MONITOUCH

Replacement Guidance

V4 Series → **Convert** → **V8 Series** **NEW**

- Panel Adapter (PAD-Vxxx)

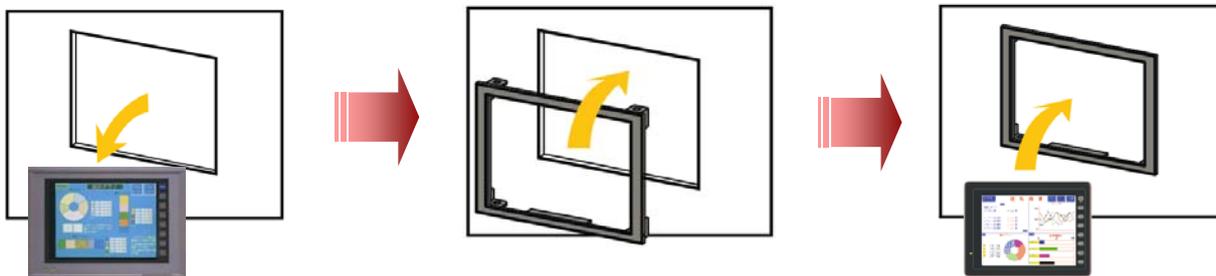
Use Panel Adapter to adjust the V4 series' panel cutout size before mounting V8 series unit.

1) Dismount V4 series unit from the panel.   2) Attach Panel Adapter (PAD-Vxxx).   3) Mount V8 series unit.
